Abbyville Hydrogeologic Peer Review

- Topics:
 - Wastewater
 - Grading Plan
 - AUL Site

Abbyville Commons
17 Lawrence Street
Norfolk, MA 02056

Private Wells

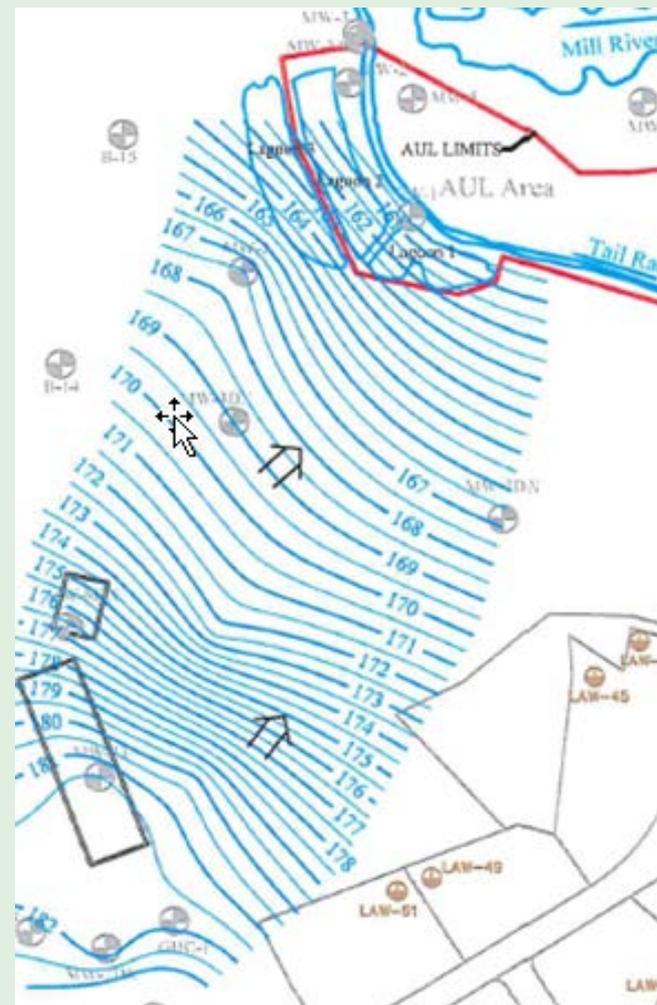
- Conductivity of Overburden Aquifer on Site Much Higher Than Fractured Bedrock
- Intersection of Overburden Aquifer With Bedrock at Bottom
- WWTF GW Flow Traveling Horizontally and Downward
- Opportunity for Significant Contribution from WWTF to Private Wells Minimal

Test Wells

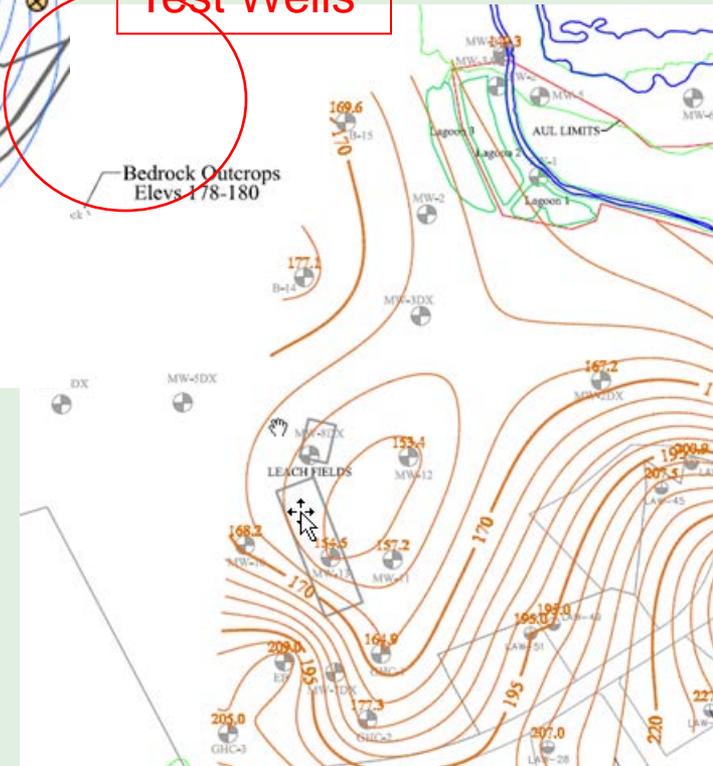
- Test Well Site Calculated to be Approx. 1-Year TOT from WWTF
- Recommend Higher Treatment Standards for WWTF for Being < 2-Year TOT
- Recommend Pre & Post Construction Monitoring

Agreed To By Applicant

Mill River Recommendations

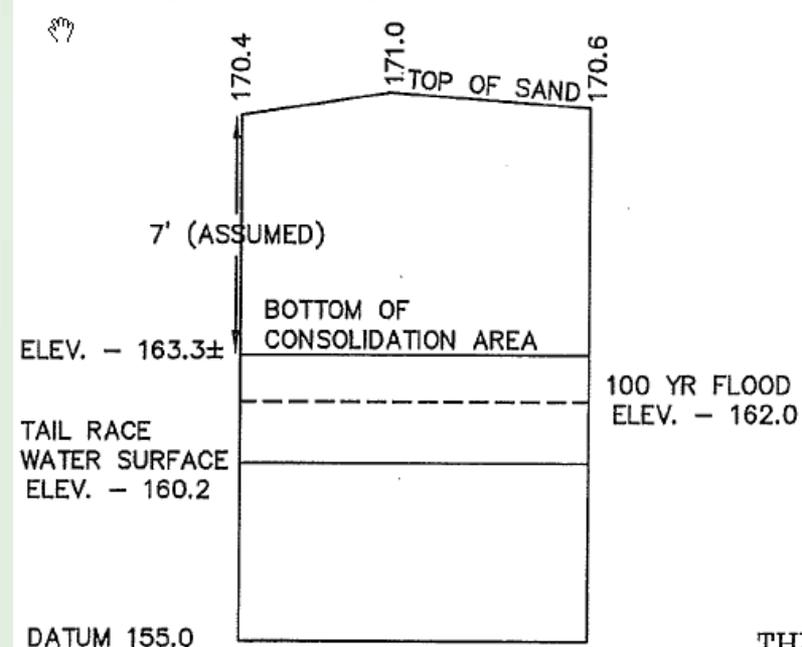
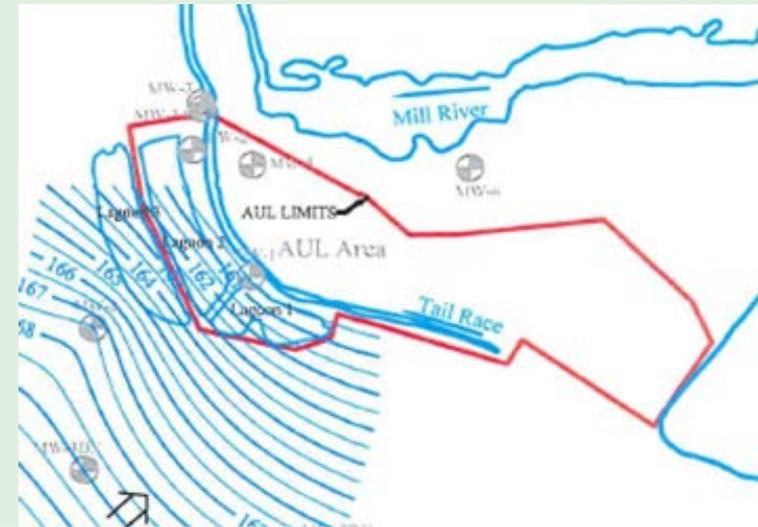
- Provide Phosphorus Mitigation to Extent Practical to Protect Town from Potential Future Regulatory Issues
 - Maximize Unsaturated Thickness Beneath WWTF Beds
 - Provide High Level P Treatment at WWTF
 - Provide Capacity for Future WWTF Expansion to Tie-in Existing Nearby Homes

Agreed To By Applicant

AUL Site

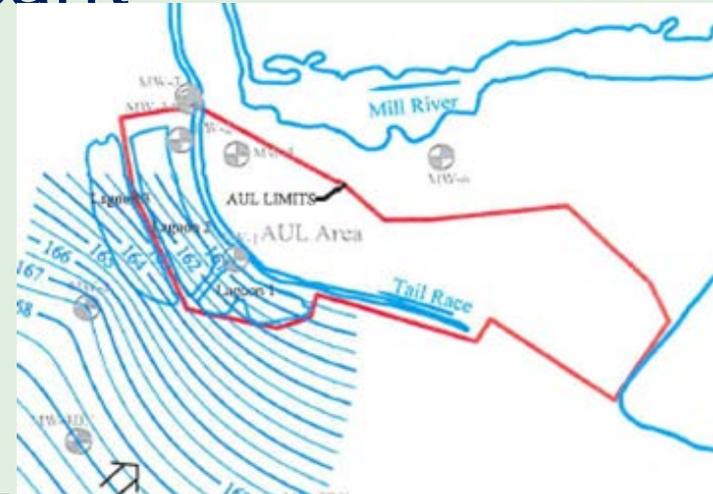
- Landfill Location Between Tail Race and River Makes Significant GW changes from Proposed WWTF Unlikely
- Sites are Closed and Under MassDEP Direction
- Applicant is Landowner and Thus Responsible Party to MassDEP
- Recommend Let MassDEP Opine if Concerned about WWTF Impacts
